Annual Inspection Report Atmore Municipal Airport

ATMORE MUNICIPAL AIRPORT ATMORE, ALABAMA

May 19, 2010

State Licensing Standards:

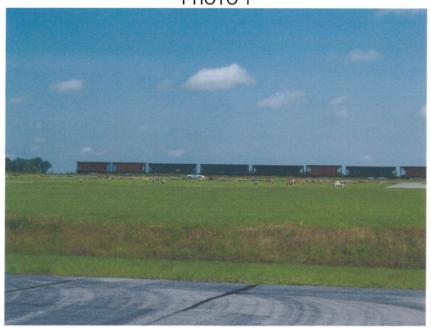
- → The approach to Runway 18 is free of obstructions. The threshold is displaced 176 feet to provide the required Safety Area. (See Section 3 Runway Safety Area)
- → The approach to Runway 36 is obstructed by a road. The threshold is displaced 270 feet to provide a clear 20:1 approach over the road.
